Commonwealth Edison
One First National Plaza, Chicago, Illinois
Address Reply to: Post Office Box 767
Chicago, Illinois 60690

Subject: Braidwood Station Units 1 and 2
Additional FSAR Information
NRC Docket Nos. 50-456/457

The Attachment to this letter provides our response to Questions 330.2, 371.7, 371.8, 371.11, and 371.13 through 371.15. Our FSAR will be amended to include the information contained in the Attachment to this letter as appropriate. Additionally, our schedule for submittal of the remaining open items is currently being discussed with Ms. Janice A. Stevens.

BRAIDWOOD-FSAR

BRAIDWOOD STATION
FINAL SAFETY ANALYSIS REPORT
FIGURE 2-1-17a
VERTICAL CROSS SECTION OF THE
KANKAKEE RIVER NEAR KLINE SIDING

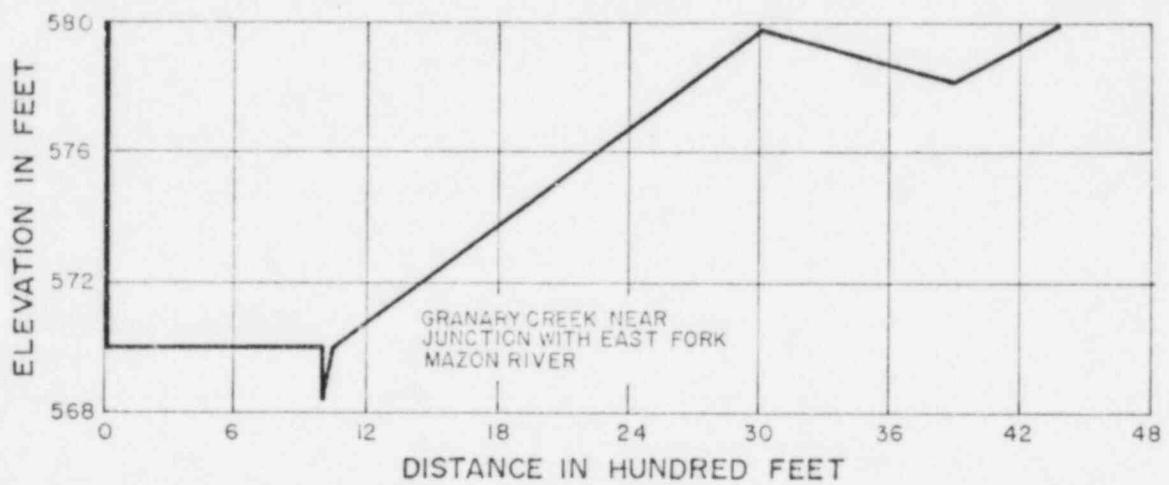
- "1. Provide additional clarification on the method used to develop the Kankakee River rating curve at the site from data at Wilmington and Custer Park and also explain how the curve was extrapolated to PMF levels. Provide a cross section of the Kankakee River at the site. If the channel cross section is not available, then provide the bankfull capacity and indicate the bankfull width on the overbank cross section.

Item 1: A typical cross section of the Kankakee River near the river screenhouse is presented in new Figure 2.4-14a (see also revised Subsection 2.4.3.5).
